FPL Energy
Seabrook Station

Docket No. 50-443
SBK-L-04116

**Supplemental Response to Request for Additional Information (RAI Nos. 2 and 3) Regarding
License Amendment Request 04-03, Application for Stretch Power Uprate**

**SUPPLEMENTAL REQUEST FOR ADDITIONAL INFORMATION
(RAI Nos. 2 and 3)
REGARDING LICENSE AMENDMENT REQUEST 04-03
APPLICATION FOR STRETCH POWER UPRATE
SEABROOK STATION
DOCKET NO. 50-443**

Figure RAI 2-1

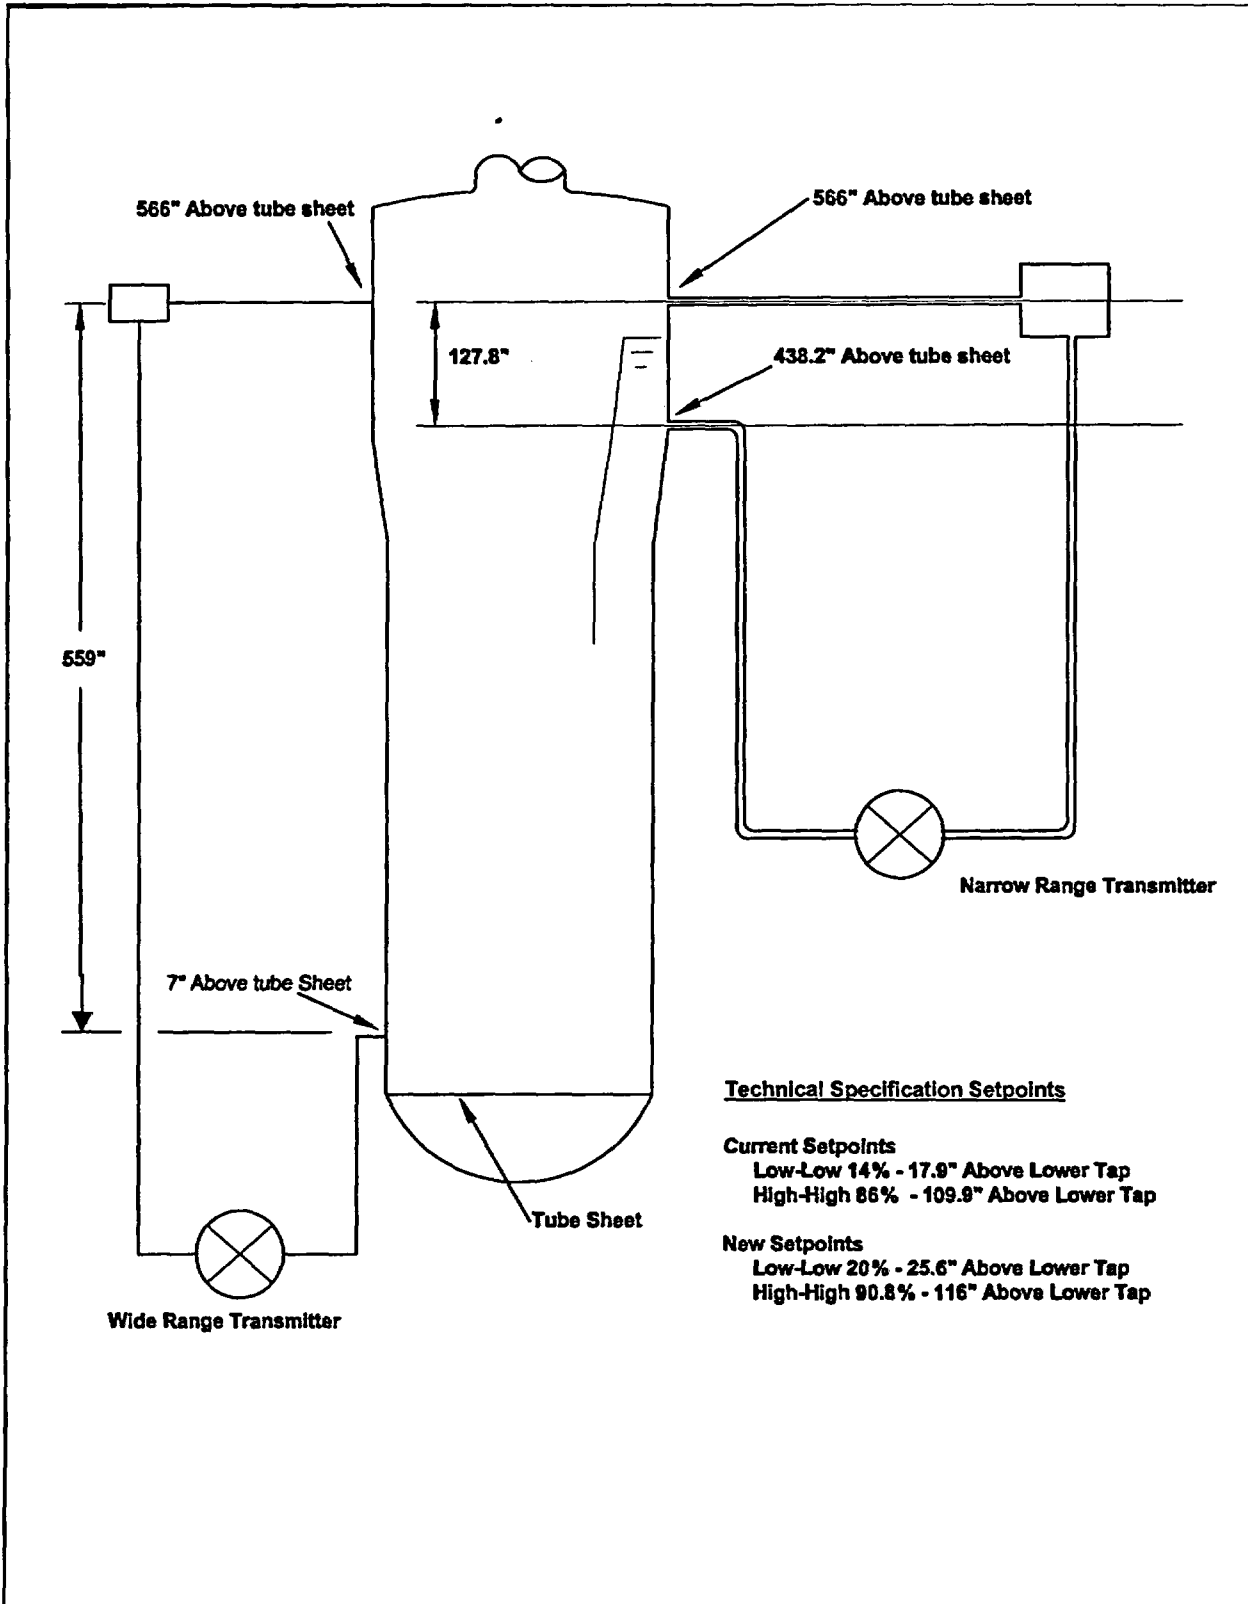
RAI #2

In each case where a setpoint is shown as a percentage of instrument span, identify the instrument by manufacturer, model and range, its span, and the actual and allowable physical values of the setpoint.

The response below supercedes the response to RAI #2 transmitted by FPL Energy Seabrook letter SBK-L-04072 dated October 12, 2004. This response is being revised to include information that addresses the span of the steam generator high-high instrumentation. The attachments to this response (Attachments RAI 2-1 and RAI 2-2) are not changed and are not being resubmitted.

For steam generator level, the transmitters are Rosemount model 1154DP4RA and the process racks are Westinghouse 7300 racks. The narrow range span is defined as the distance between the lower instrument tap and the upper instrument tap. The distance is 127.8 inches – see Figure RAI 2-1. The transmitter range is 150 inches of water column (W.C.) and the calibrated span is 85.72 inches of water column. The process rack range and span is 0 – 10 volts D.C. The physical unit of measure for this function is level. Based on the tap to tap distance of 127.8 inches, the previous Technical Specification low level setpoint of 14% narrow range span is 17.9 inches above the lower tap and the previous Technical Specification high level setpoint of 86% narrow range span is 109.9 inches above the lower tap. The setpoint change for the SPU is 20% of narrow range span which is 25.6 inches above the lower tap and the high level setpoint change is 90.8 % of narrow range span which is 116 inches above the lower tap.
